Appendix II

Confirmatory Debris Generation Analyses

Figure II-1. Comparison of Jet Isobar Volumes

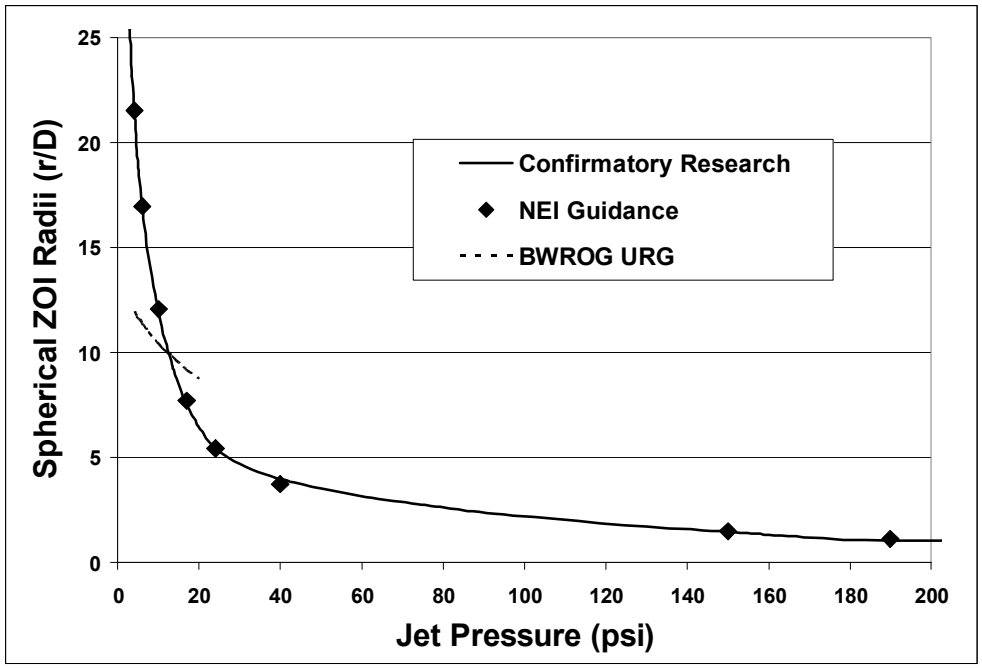
As shown, at the lower jet pressures, the pressure isobar volumes are much larger for the PWR two-phase LOCA jet than for the BWR steam jet. A principal reason for this difference is the higher energy associated with the higher pressure of a PWR reactor coolant system (RCS) than with a BWR RCS; however, another consideration is the accuracy of the ANSI/ANS-58.2-1988 standard at the lower pressures. For example, the validity of the assumption in the ANSI/ANS-58.2-1988 standard that the jet expands at a

half angle of 10 degrees once the jet expansion has reached the asymptotic plane becomes more important at the lower expansion pressures. The accuracy of the debris volumes of insulations that damage significantly at the lower jet pressures is subject to the accuracy of this assumption. Note that the confirmatory research and NEI-recommended-equivalent spherical ZOI radii are in good agreement.

Figure II-2. LDFG Damage Curve for Small Fine Debris

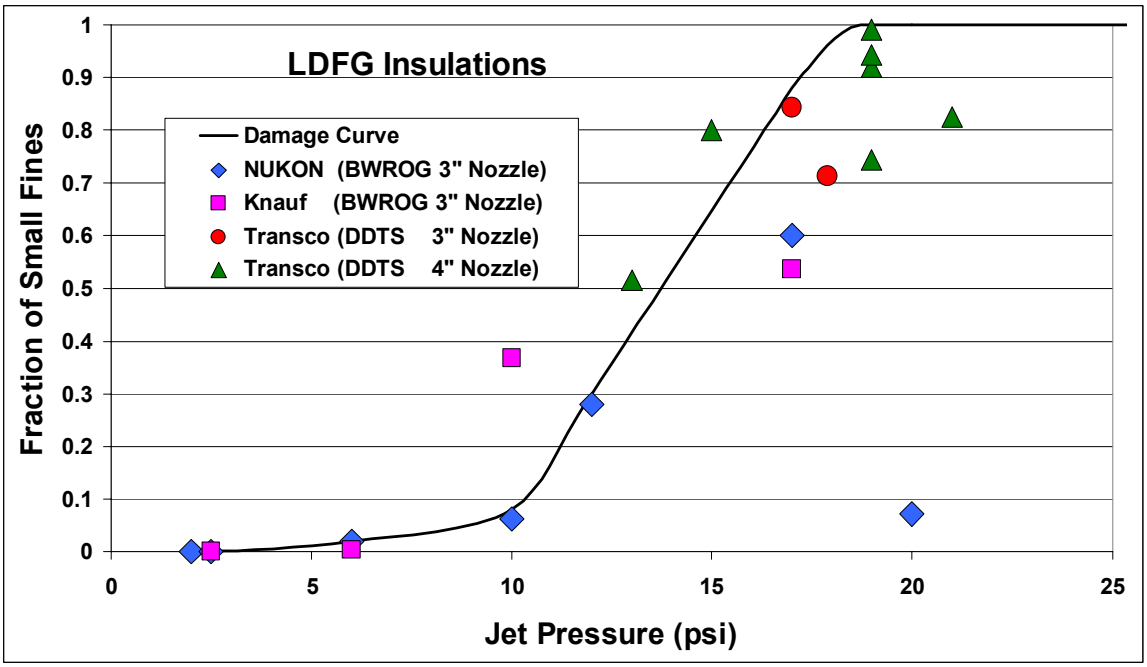
Figure II-2 plots the fractions for the small fines from the AJIT debris generation test data as a function of the jet centerline pressure for these three types of LDFG insulations. A curve drawn through the data represents the damage as a function of jet pressure for use in the damage integration over the ZOI. One set of seven data points was from tests (in the DDTS) that used a 4-in. nozzle, whereas the remainder used a 3-in. nozzle. The 4-in. nozzle data from the DDTS generally shows more damage than do the 3-in. nozzle tests. In general, the higher damage occurred because the larger diameter jet exposed more of the target insulation blanket to higher pressures. Note that the data were correlated by the estimated jet centerline pressure, but the pressure on the blanket decreased outward from the centerline. When the blanket was placed close to the jet, the ends of the blanket were hit with substantially less force of flow than the centerline for which the data were correlated. For example, the 3-in. nozzle data point for NUKON™ at a jet pressure of 20 psi damaged only approximately 7 percent of the insulation into small fine debris, whereas this pressure totally destroyed the TPI blankets in the 4-in. nozzle. Apparently, testing blanket destruction for insulations requiring a pressure higher than approximately 17 psi requires a jet nozzle larger than 3 in. For LDFG, any jet pressure larger than 17 psi will totally destroy the blanket into small fine debris, whereas the NEI guidance cited an OPG two-phase jet test with 52 percent of the insulation damaged into small fine debris as its basis of conservatism.

Another significant point of discussion is that the threshold of damage for LDFG insulation has been specified as 10 psi, where Figure II-2 clearly shows damage at jet pressures less than 10 psi. Apparently, neglecting the tail of the damage curve was considered acceptable for the BWR strainer resolution because of the lesser BWR jet volumes at lower pressures, as shown in Figure II-1. However, the much larger jet volumes below 10 psi for the Confirmatory Research/NEI Guidance PWR jet shown in Figure II-1 make the neglect of the tail less acceptable.

Figure II-3. Potential Volumes of Small Fine LDFG Debris

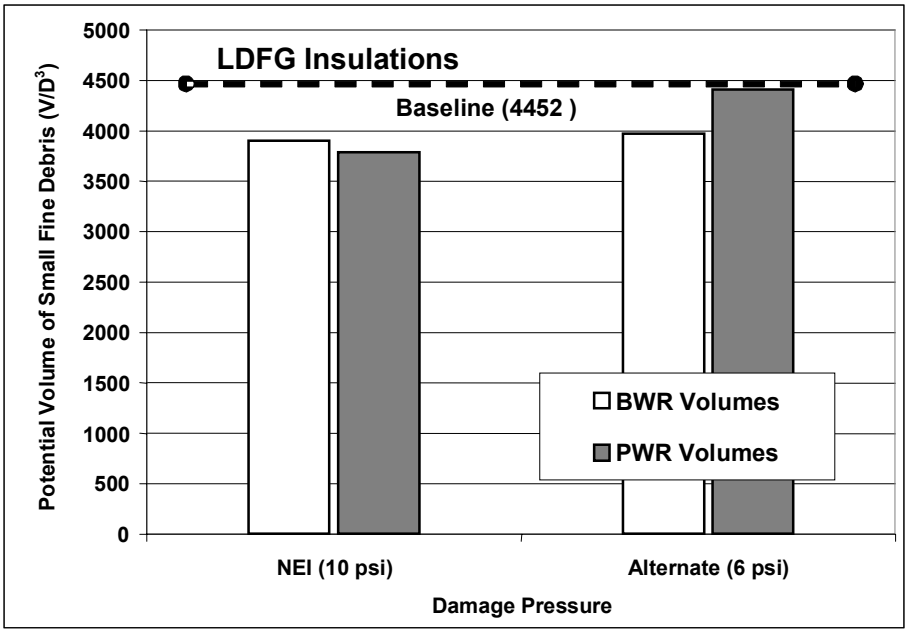
Table II-2 provides the results of debris-size distribution integration over the ZOI. A lower alternate damage pressure results in a larger equivalent spherical ZOI; however, a lesser fraction of the debris is damaged into small fine debris. The use of the alternate damage pressures over the NEI-recommended damage pressures for PWR analyses would result in approximately 16 percent more small fine debris. Figure II-3 compares the potential debris volumes and provides an estimate using the baseline guidance. The baseline estimate is simply 60 percent of $4\pi/3\ (12.1/D)^3$. As shown, the baseline guidance appears to be conservative, but not overly so.

- A comparison of the NUKON™ results with the BWROG URG steam jet model illustrates that the neglect of the tails of the debris damage curve has a larger impact for PWRs than for BWRs (see Figure II-3).

Figure II-4. Temp-Mat Damage Curve for Small Fine Debris

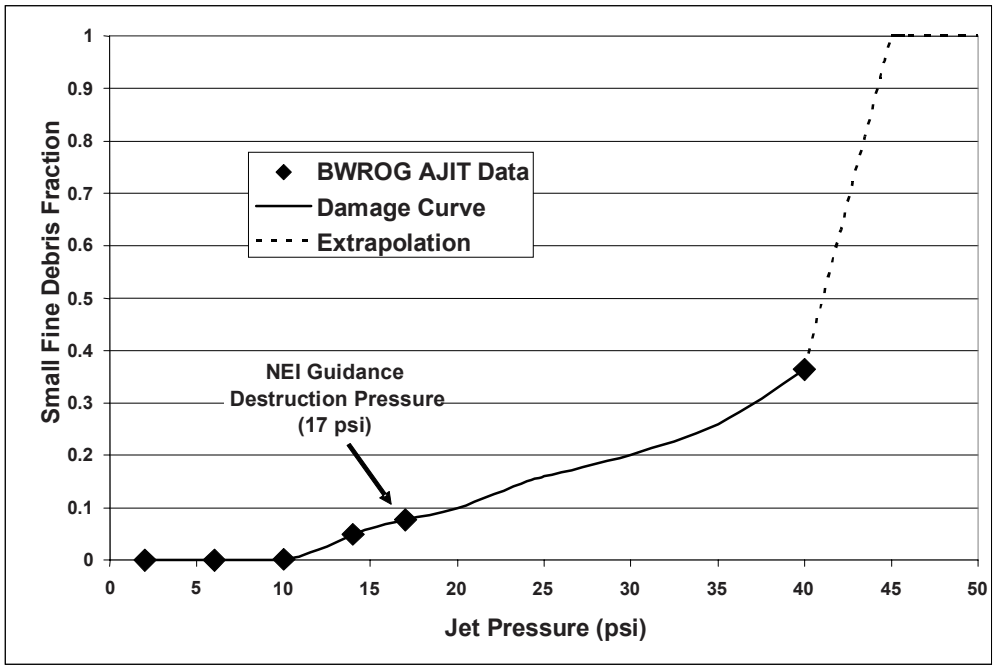
Figure II-4 shows the Temp-Mat insulation debris fractions for the small fine debris from the AJIT tests. This figure shows six data points for Temp-Mat, two of which represent tests where no significant damage was noted. The test with the maximum damage had approximately 36 percent of the insulation damaged into small fine debris, with the remainder of the insulation forming large-piece debris. Unfortunately, no tests were conducted with jet pressures high enough to complete the damage curve to total destruction into small fine debris, as was done for the LDFG insulations. Therefore, a conservative extrapolation of the data is required to perform the debris generation integration over the equivalent ZOI sphere. Figure II-4 shows the extrapolation used herein as a dashed line. Figure II-4 also illustrates the selection of the NEI-guidance damage pressure of 17 psi, where it is seen that significant small fine debris is generated at jet pressures below 17 psi.

Figure II-5. Potential Volumes of Small Fine Temp-Mat Debris

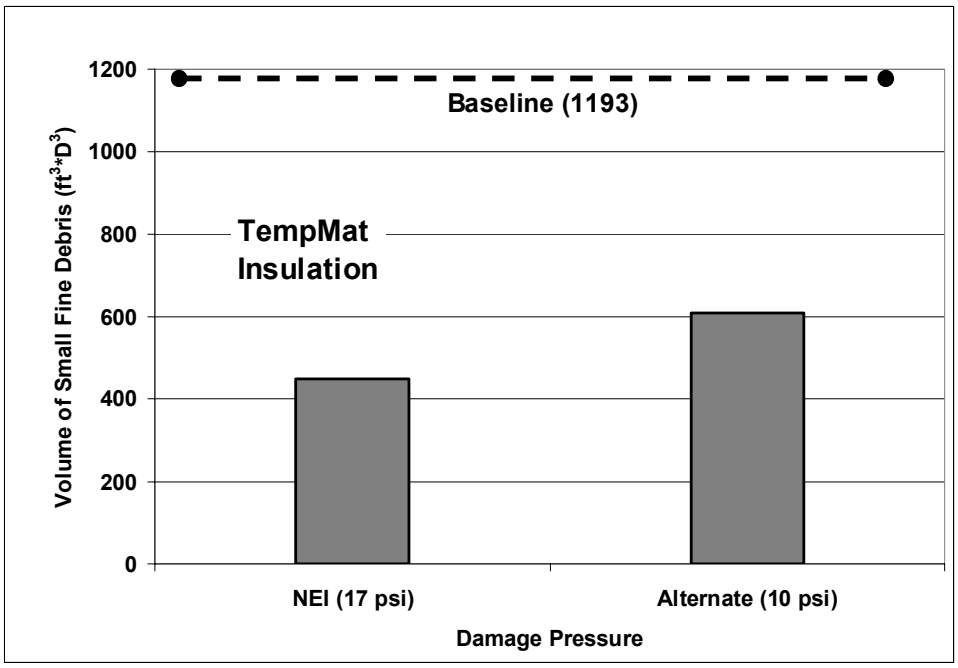
Table II-3 provides the results of the Temp-Mat debris-size distribution integration over the ZOI. Figure II-5 compares the potential debris volumes and provides an estimate using the baseline guidance (60 percent of $4\pi/3\ (7.8/D)^3$). A lower alternate damage pressure results in a larger equivalent spherical ZOI; however, a lesser fraction of the debris is damaged into small fine debris. The use of the alternate damage pressures over the NEI-recommended damage pressures for PWR analyses would result in approximately 36 percent more estimated small fine debris. For Temp-Mat insulation, the baseline is conservative with respect to both the NEI-guidance damage pressure of 17 psi and the alternate pressure of 10 psi.

Figure II-6. K-Wool Damage Curve for Small Fine Debris

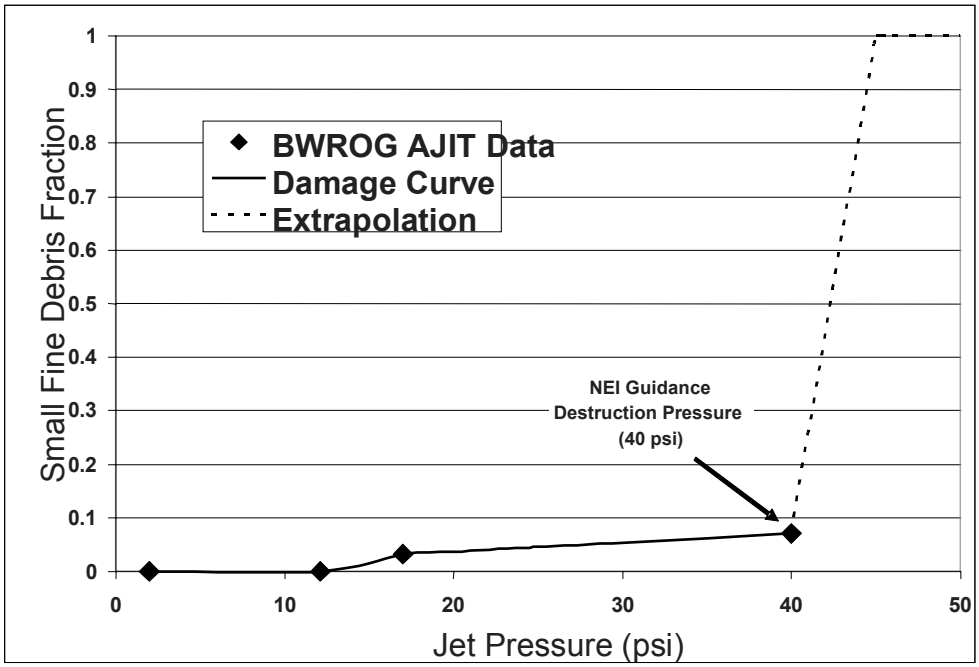
insulation debris fractions for the small fine debris from the AJIT tests. This figure shows only four data points for K-wool, two of which represent tests where no significant damage was noted. The test with the maximum damage had approximately 7.1 percent of the insulation damaged into small fine debris, with much of the remainder of the insulation still contained in the blanket cover and still attached to the target mount. As with the Temp-Mat data, the K-wool damage curve is incomplete because the highest jet pressure tested was that of the NEI-recommended damage pressure. To perform the debris generation integration over the equivalent ZOI sphere, the test data were conservatively extrapolated, as shown in Figure II-6.

Figure II-7. Potential Volumes of Small Fine K-Wool Debris

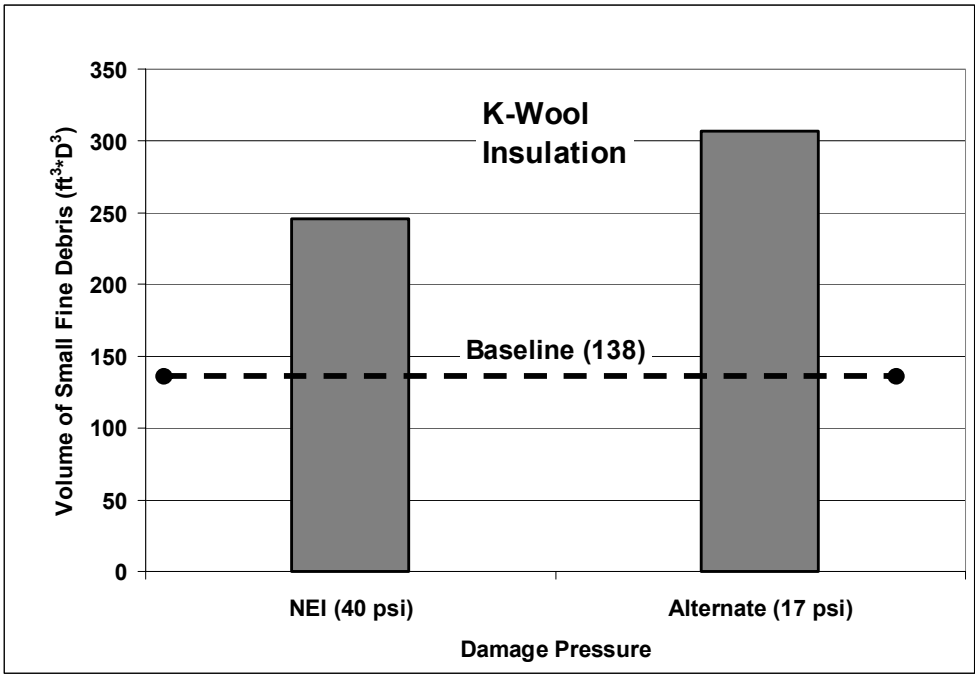
Table II-4 provides the results of the K-wool debris-size distribution integration over the ZOI. Figure II-7 compares the potential debris volumes and provides an estimate using the baseline guidance (60 percent of $4\pi/3\ (3.8/D)^3$). The lack of debris generation data for a jet pressure higher than the NEI-recommended destruction pressure of 40 psi makes K-wool integration difficult. Therefore, to ensure conservative debris-size integration, it must be assumed that the insulation is completely destroyed at a pressure higher than 40 psi (i.e., the integration herein assumed to be 100 percent at 45 psi). However, this assumption may be overly conservative. For K-wool insulation, the baseline is not conservative with respect to either the NEI guidance damage pressure of 40 psi or the alternate pressure of 17 psi.

Figure II-8. Comparison of Fibrous Insulation Damage Curves

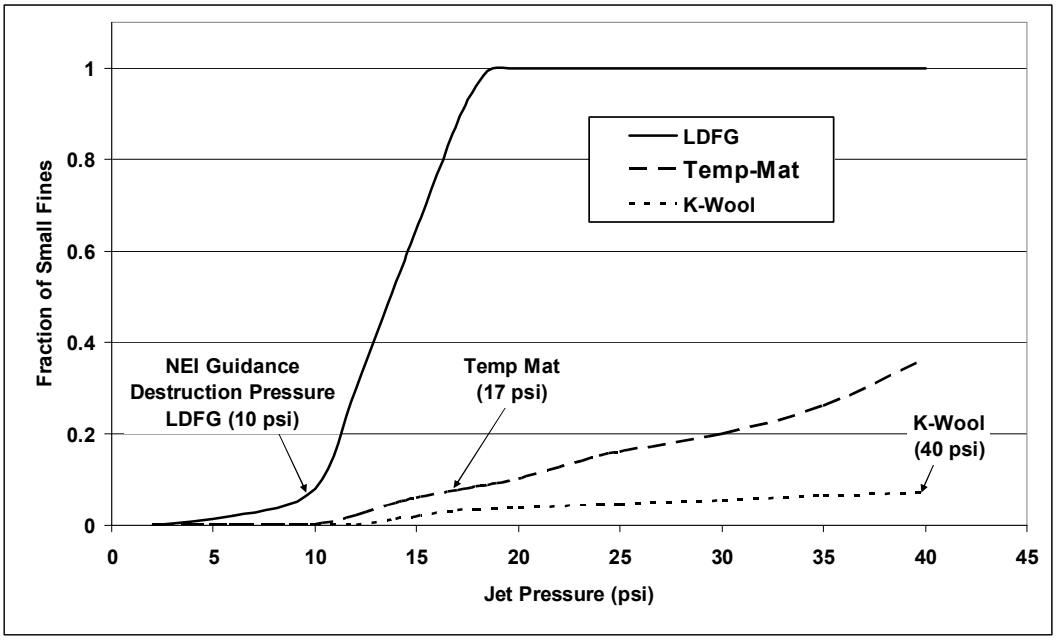
This damage curve comparison for LDFG, Temp-Mat, and K-wool does seem to support the concept that a higher destruction pressure results in the fractions of small fines becoming increasingly smaller as the destruction pressure increases. Certainly this is the case for Temp-Mat, where the baseline guidance is conservative relative to the integration herein and both the fractions of small fine debris and the potential debris volumes are smaller than the baseline guidance. Although this case is likely true for K-wool as well, it cannot be proven conclusively because of the complete lack of data beyond the NEI-recommended destruction pressure.

- The NEI guidance recommendation that adapts the debris-size distribution for NUKON™ to other types of fibrous insulation that have a destruction pressure higher than that of NUKON™ has been partially supported (see Figure II-8), although it cannot be conclusively ensured.

Figure II-9. TPI Stainless-Steel RMI Small-Fine-Debris Fractions

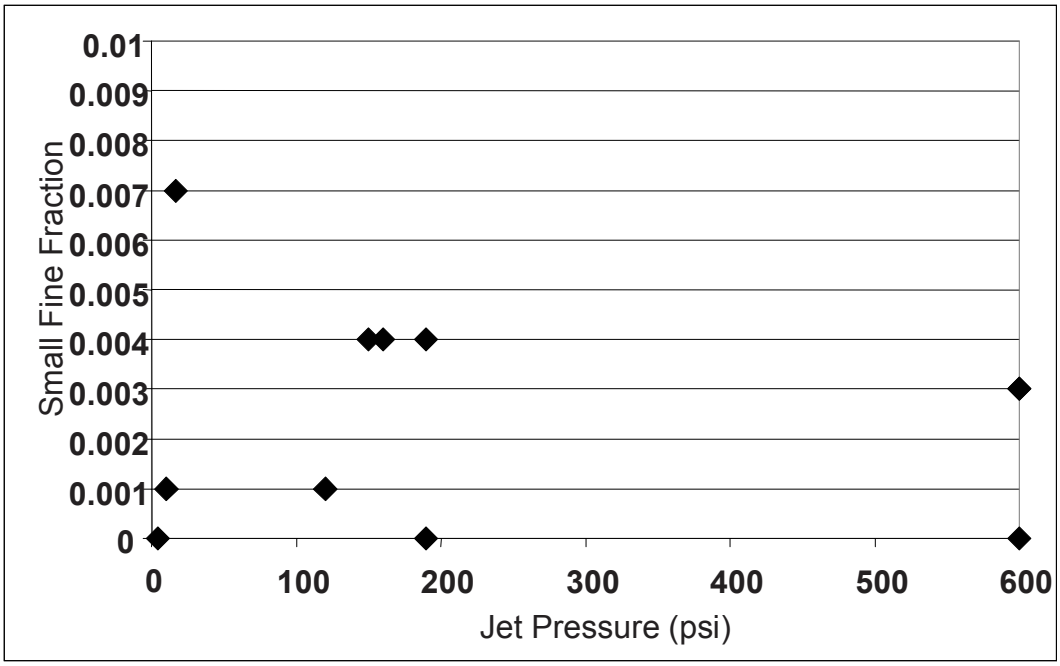
TPI manufactures stainless-steel and aluminum RMI insulation. The NEI guidance recommends a destruction pressure of 190 psi for the TPI RMI. The TPI cassettes tested included both aluminum and stainless-steel foils encased in stainless-steel sheaths secured with latches and strikes (no bands were used). Although the recommended destruction pressure is 190 psi, a small amount of fine debris was noted for jet pressures as low as 10 psi (Test 21-3). On the other hand, only small quantities of fine debris (i.e., less than 0.5 percent) were found for tests with jet pressures as high as 600 psi. Figure II-9 shows the debris generation fractions for TPI stainless-steel RMI small fine debris.

Table II-7 compares potential debris volumes when estimated using the NEI baseline guidance and when acknowledging debris generation at jet pressures as low as 10 psi. As stated above, to obtain actual volumes of debris, the potential volumes must be multiplied by the insulation concentration and again by D^3. For the baseline estimate, the volume associated with a ZOI radius of 1.3/D is multiplied by 75 percent to obtain the baseline potential volume. For the alternate estimate, the ZOI volume out to a jet pressure of 10 psi was multiplied by 0.5 percent to obtain the alternate potential volumes. The application of the alternate pressure results in approximately three times as much small fine debris as using the baseline guidance. However, even these quantities are not very large compared with such insulations as LDFG.

Figure II-10. DPSC Mirror Damage Curve for Small Fine Debris

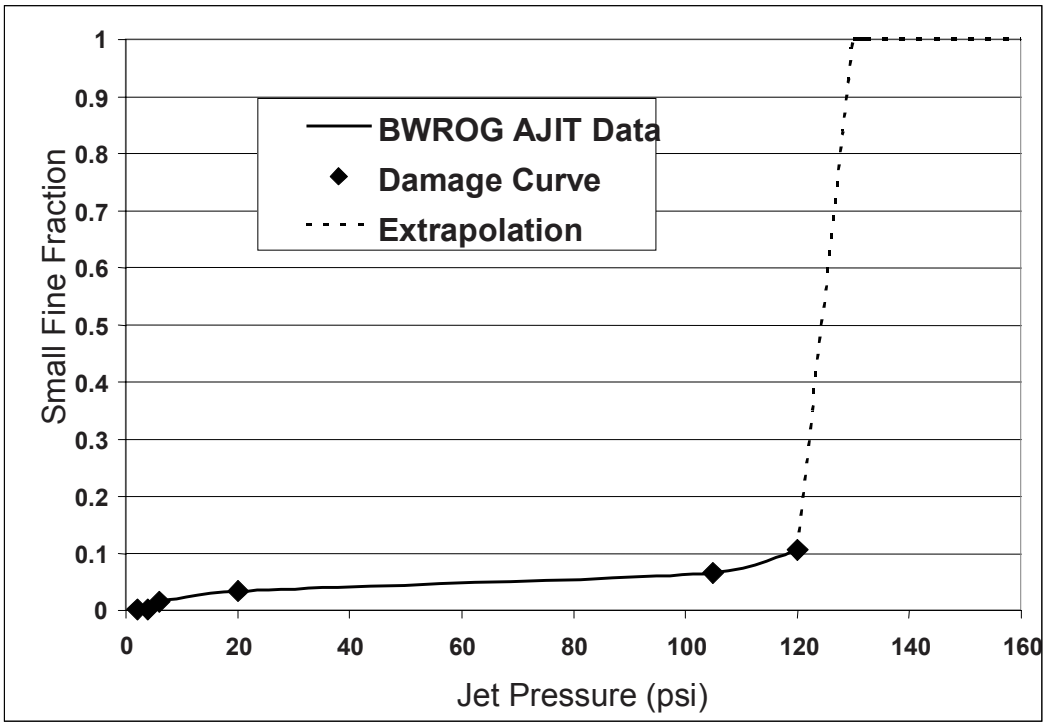
Figure II-10 shows the debris fractions for the small fine debris from the AJIT tests. In the figure, the small fine debris was correlated as pieces less than 6 in., although the NEI guidance specified RMI small fines as less than 4 in.; therefore, a small measure of conservatism was added to the comparison. Figure II-10 shows six data points for Mirror®, with two of those tests generating very minor quantities of small fines. Note that with the lower pressure test, where the RMI cassette was exposed to a jet pressure of only 2 psi (AJIT Test 18-3), the cassette was still detached from the target mount, leaving two half cassettes on the chamber floor. The test with the largest quantity of small fine debris (AJIT Test 17-1) had only 10.6 percent of the foils turned into pieces less than 6 in., with the remaining foils becoming large-piece debris. The conservative extrapolation shown in Figure II-10 to complete the spherical ZOI debris fraction integration assumes complete destruction at a jet pressure of 130 psi. Note that in the single NRC-sponsored Mirror® debris generation test conducted at the KWU test facility, the test article was completely destroyed.

Table II-8 provides the results of the Mirror® debris-size distribution integration over the ZOI. The potential debris volume of $661/D^3$ is quite low compared with an estimate using the baseline guidance (i.e., 75 percent of $4\pi/3\ (21.6/D)^3$) of $31660/D^3$. Although this insulation is damaged at jet pressures as low as 4 psi, a relatively small amount of small debris is formed at pressures less than approximately 120 psi, and when the debris damage data are applied to the larger ZOI radius of 21.6/D, only a small fraction of the insulation in that sphere becomes small fine debris. For DPSC Mirror® RMI insulation, the assumption in the NEI baseline guidance that 75 percent of the insulation within a 21.6/D ZOI sphere would become debris less than 4 in. in size (i.e., $31{,}660/D^3$) is overly conservative. However, the quantities of large-piece debris, including nearly intact cassettes, could be very large because even 2 psi can detach the cassettes, which could become very important in containments where the transport velocities are high enough to move this heavier debris significantly.
